Community Solar Project Interconnection
Community Solar Project Tier 2 Review

("Applicant")
OCS012

Proposed Interconnection
On PacifiCorp's
Circuit 5P15 out of Kennedy substation at approximately 45.589361,
-122.634028

May 13, 2020

Figure 2: One Line Diagram

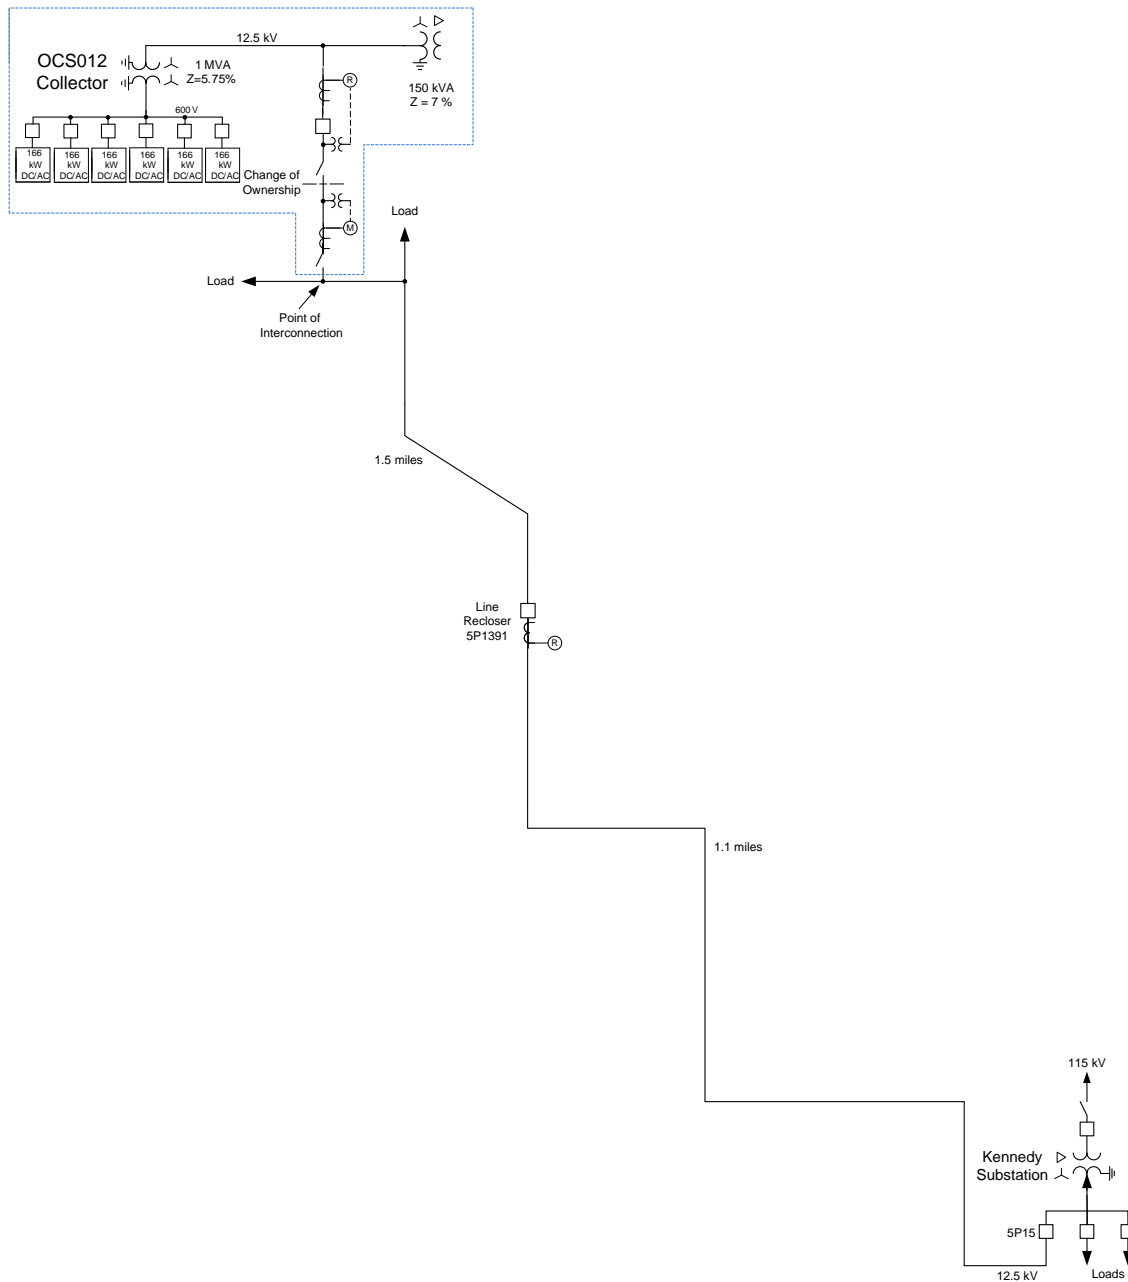
As discussed in the initial scoping meeting for the OCS012 project, the project will be connected to a four-wire multi-grounded circuit. The equipment proposed by the Applicant in their project one line diagram does not make the project an effectively grounded source to the 12.5 kV circuit. A grounding transformer as shown in Figure 2 can be added to satisfy this requirement.

A 12.5 kV grounding transformer will need to be installed as part of the Applicant's generating facility.
